## ORIGINATION FORM

Proposed Revisions to a Standard Plans Index  
(Please provide all information — Incomplete forms will be returned)

Index Number: 520-005  
Sheet Number (s): All  
Index Title: Concrete Shoulder Gutter Spillway

DETAIL OF CONCRETE SPILLWAY AT END OF SHOULDER GUTTER  
 (TO BE USED WHERE INLETS, PIPES & ENDWALLS ARE IMPRACTICAL)

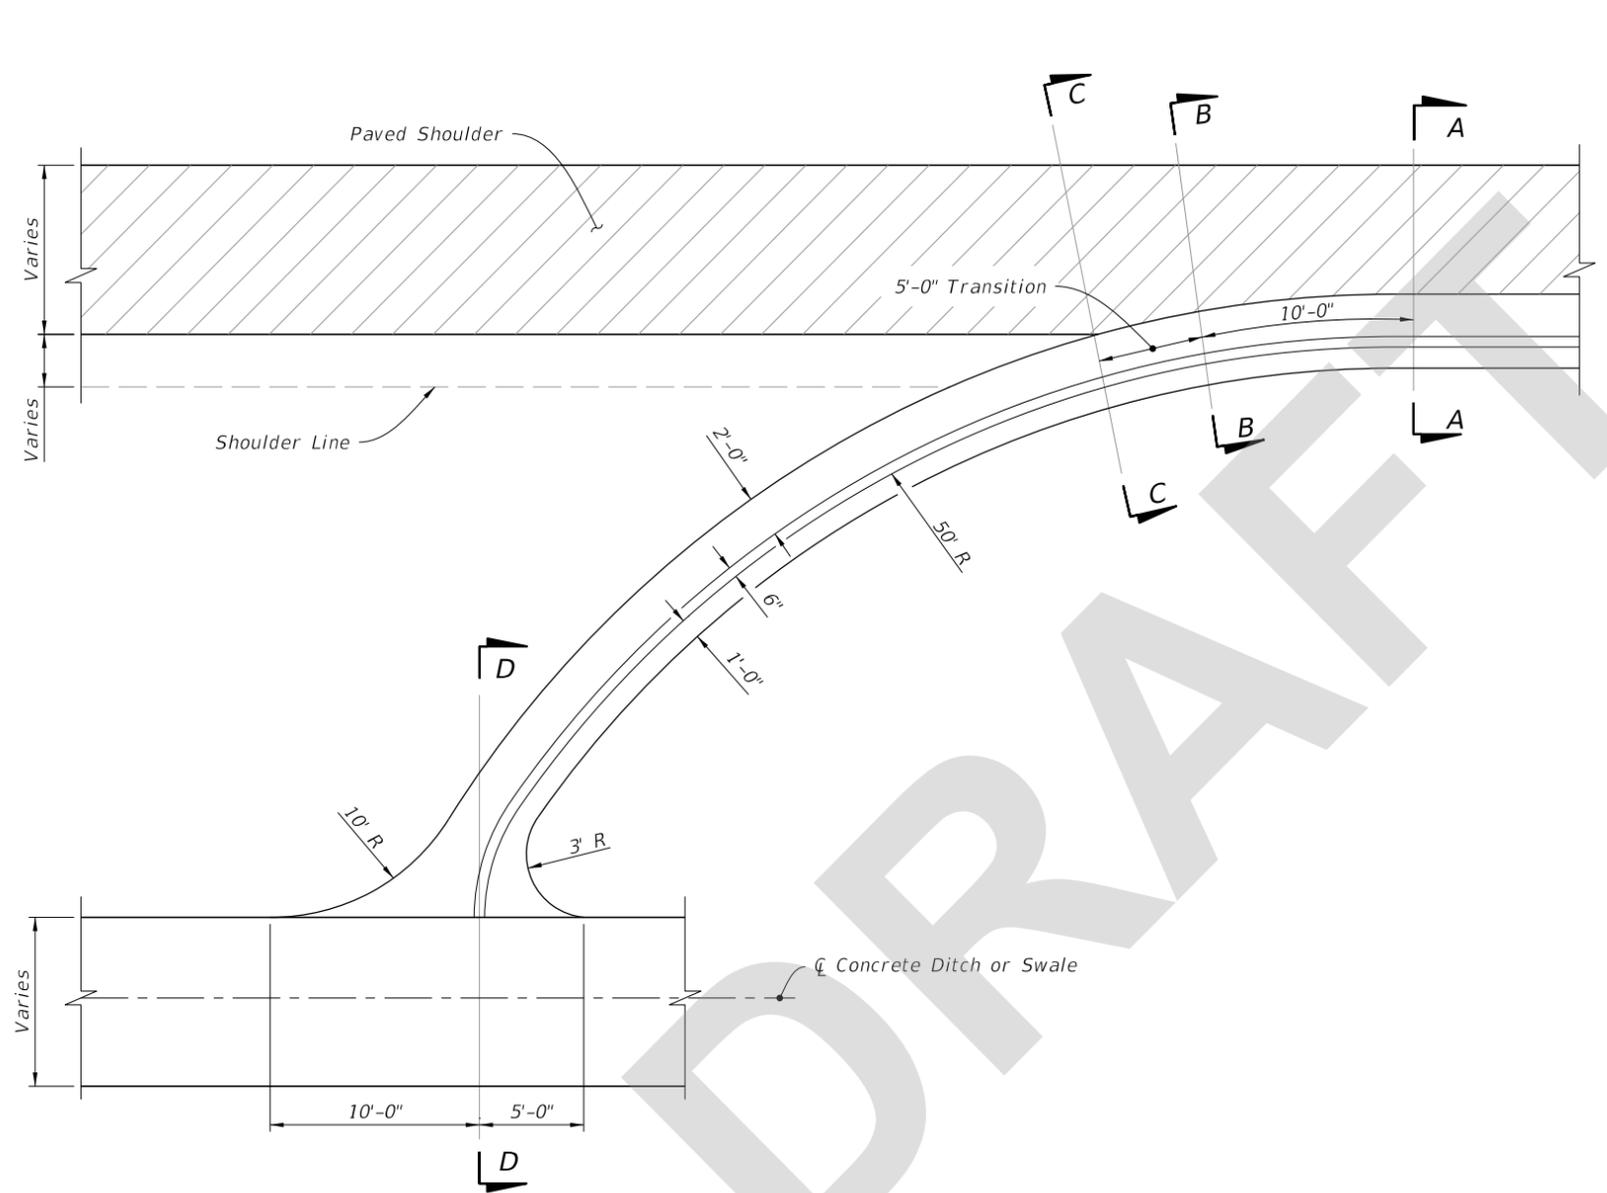
REDEVELOPED INDEX

- ~~1. Spillway to be paid for as Shoulder Gutter, L.F.~~
- ~~2. If spillway empties into an unpaved ditch, the detail should be modified as necessary.~~

CONCRETE SPILLWAY AT END OF SHOULDER GUTTER DETAILS

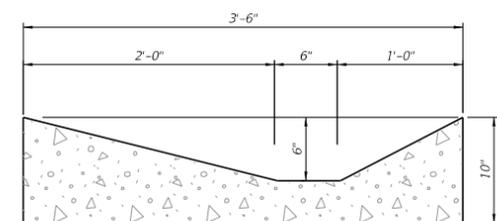
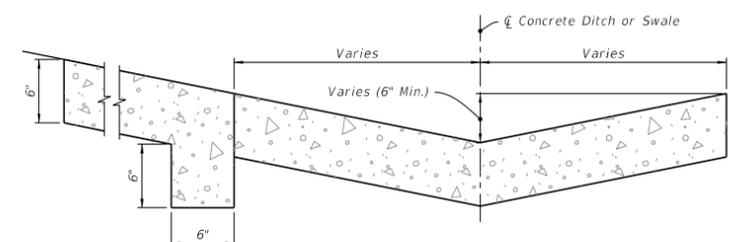
Deleted notes; redrew details.

Redeveloped Index and deleted notes that are now covered in the SPI.
